BOSCH M7.4.4

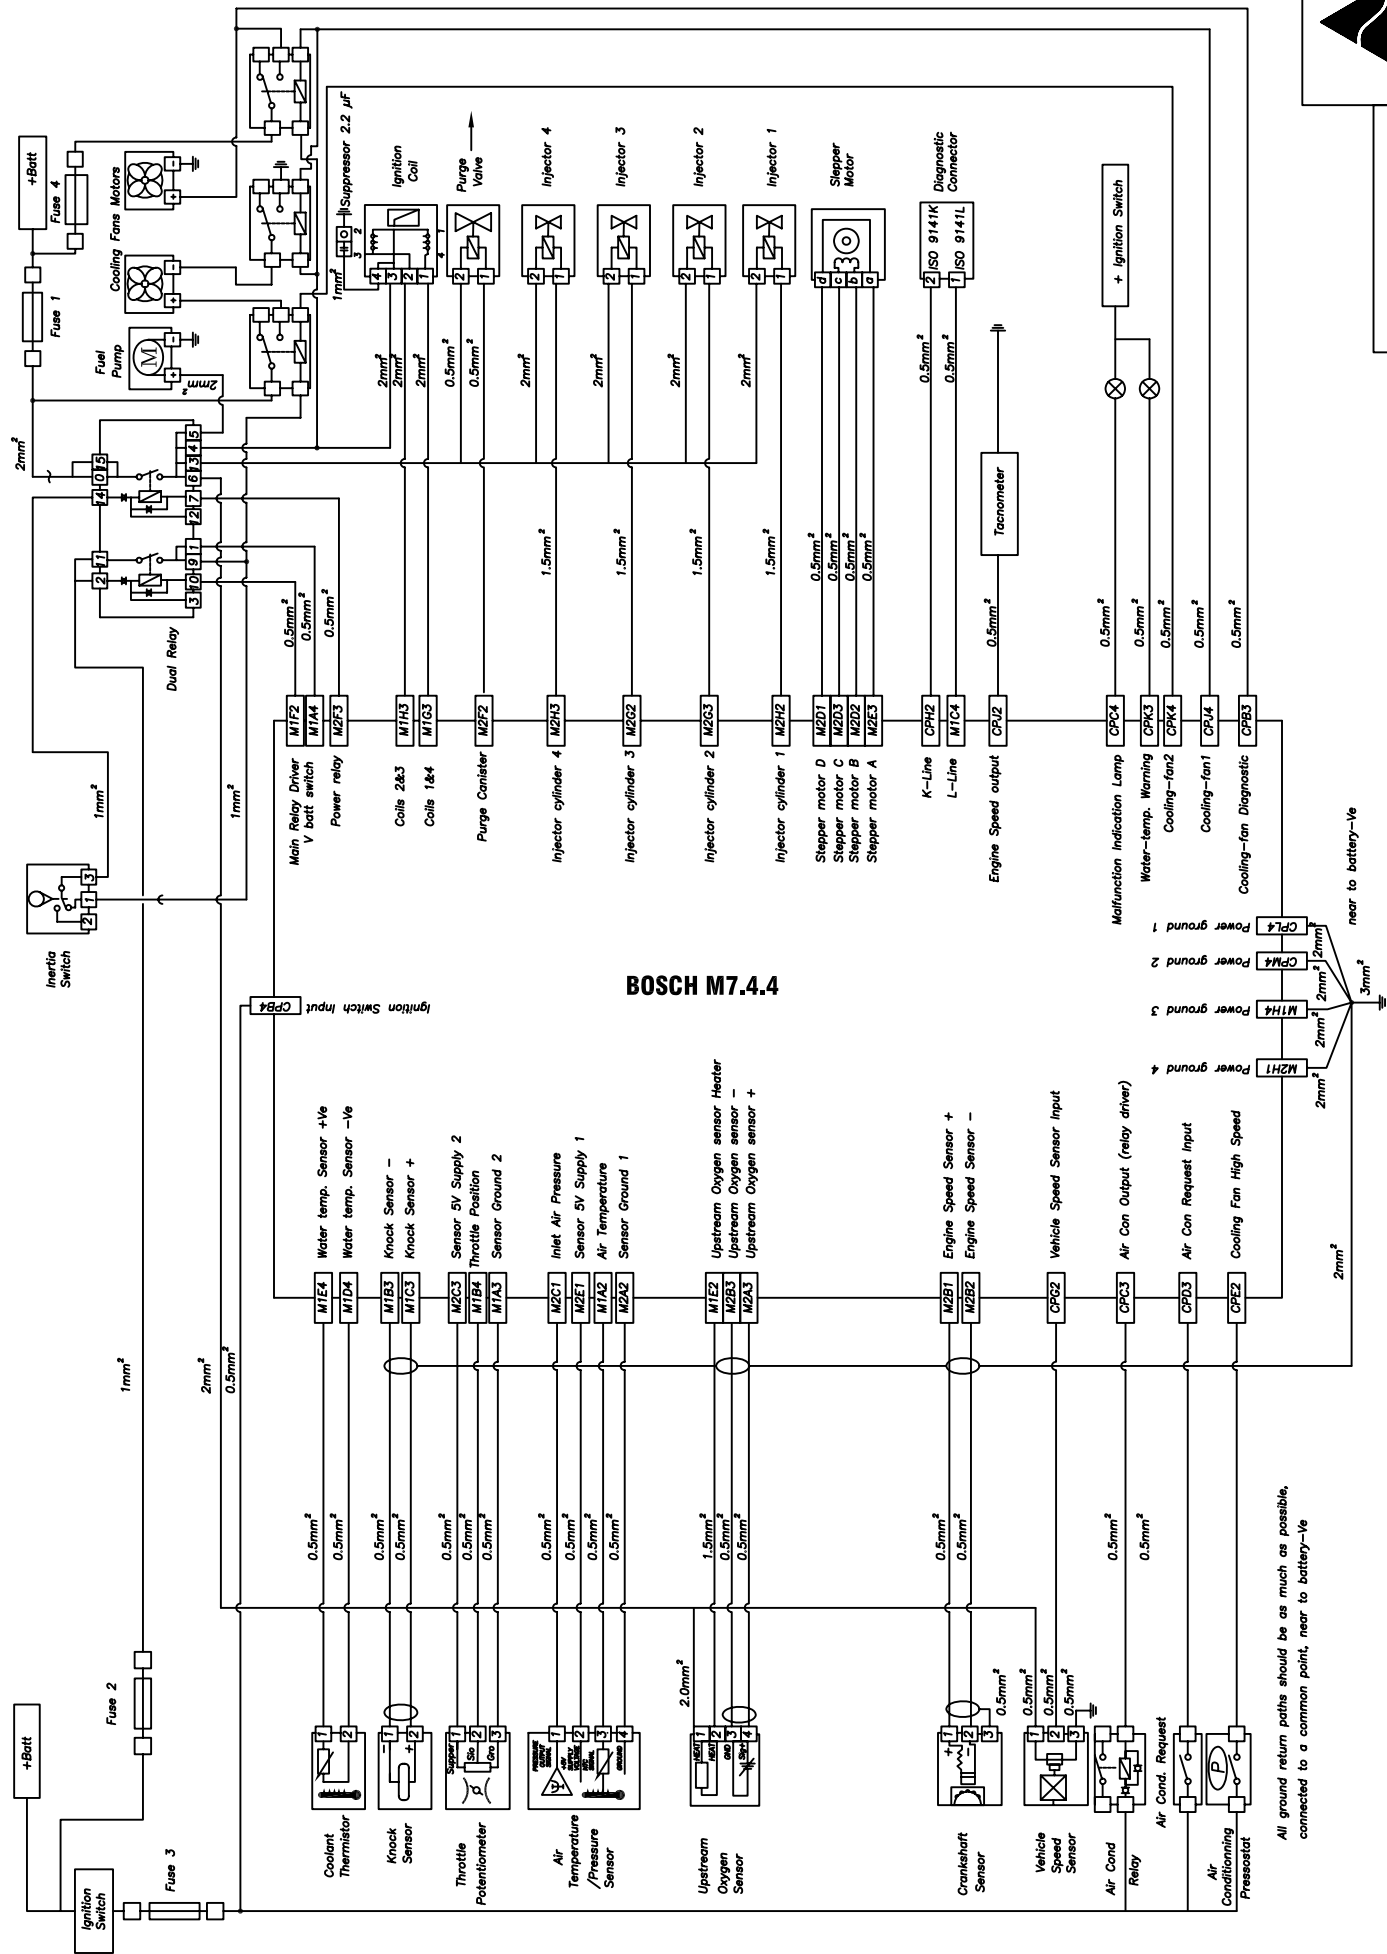
All ground return paths should be as much as possible, connected to a common point, near to battery-Ve
